CPED STAFF REPORT

Prepared for the Heritage Preservation Commission
HPC Agenda Item #3
September 29, 2015
BZH-28845

Property Location: 708 1st Street North
Project Name: Rooftop access and deck reconstruction
Prepared By: Aaron Hanauer, Senior City Planner, (612) 673-2494
Applicant: Margo Tolins and John Mejia
Project Contact: Mark Tambornino
Ward: 3
Neighborhood: North Loop Neighborhood Association
Request: To allow for a roof deck and penthouse rebuild.
Required Applications:

1 A1.2 Roof
SCALE: 1/4" = 1'-0"

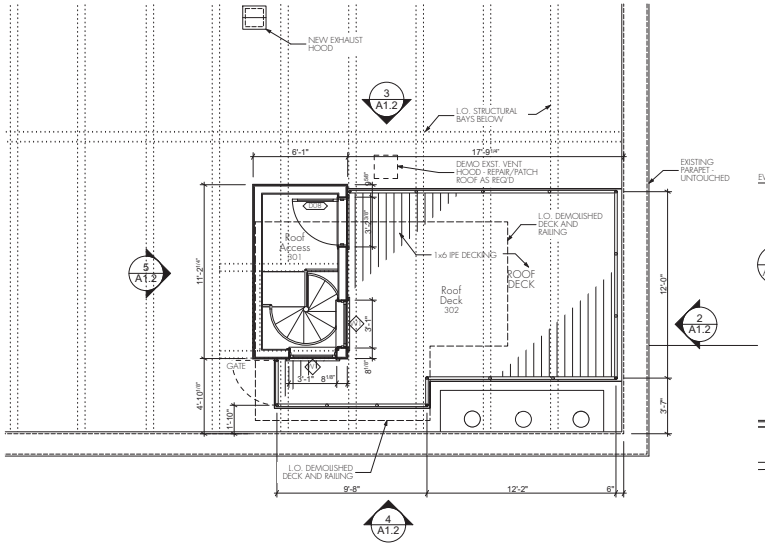
The applicant's proposal will not impact the existing building's cornice, parapet or other historic elements, nor will it be visible from the primary building elevation along 1st Street North. However, as proposed, the rooftop deck and railing would be located less than one structural bay from the northeastern and southeastern building elevations and be visible from West River Parkway North; the building's first structural bay is located approximately 10'-8" from the interior of the northeastern building wall and 18'-3" from the interior of the southeastern building wall. The deck railing would be located approximately four inches from the interior of the northeastern building wall and 1'-10" from the interior of the southeastern building wall. The top of the deck railing would be 42 inches above the rooftop deck. The building's northeastern elevation contains a 1'-8" tall parapet (measured from the top of the rooftop deck). Therefore, the railing would project approximately 1'-10" above the parapet. The *Minneapolis Warehouse Historic District Design Guidelines* state the following in the Guidelines for Existing Buildings-Rooftop Addition section: "In cases where a rooftop addition is allowed the guidelines are intended to minimize visibility of the addition from the public street by limiting its footprint, scale, height and mass." If the applicant maintained the 7'-6" setback from the interior

of the northeastern building wall, as is currently the case with the existing rooftop deck, the deck railing would not be visible from West River Parkway North. In addition, if the applicant stepped the rooftop deck back 2'-6" form the interior of the southeast building wall, the deck railing would be less visible from West River Parkway North as it would be behind existing mechanical equipment. Therefore, CPED is recommending that the rooftop deck and railing be located 7'-6" feet from the interior of the northeastern building wall and 2'-6" from the interior of the southeastern building wall.

The proposed penthouse will be set back 17.9 feet from the interior of the northeastern building wall. This exceeds the 15 foot or one structural bay requirement, as the first structural bay from the interior of the northeastern building wall is approximately 10.8 feet. The penthouse will also be less than 14 feet in height measured from the structural roof deck of the existing building; the proposed penthouse would be 11 feet in height measured from the structural roof deck. In addition, the design and materials of the rooftop penthouse, which would be clad in fiber cement panels painted dark bronze to match the neighboring rooftop structures, will help the penthouse be clearly differentiated from the historic building in a way that does not detract from the character of the historic building or the district. It is recognized that the penthouse will be set back only 4'-10" from the interior of the southeastern building wall, which is less than one structural bay; however, this is an existing condition and requiring the applicant to move the penthouse one structural bay would require significant interior building and exterior roof alternations.

1. The rooftop deck and railing shall be located 7'-6" feet from the interior of the northeastern building wall and 2'-6" from the interior of the southeastern building wall.
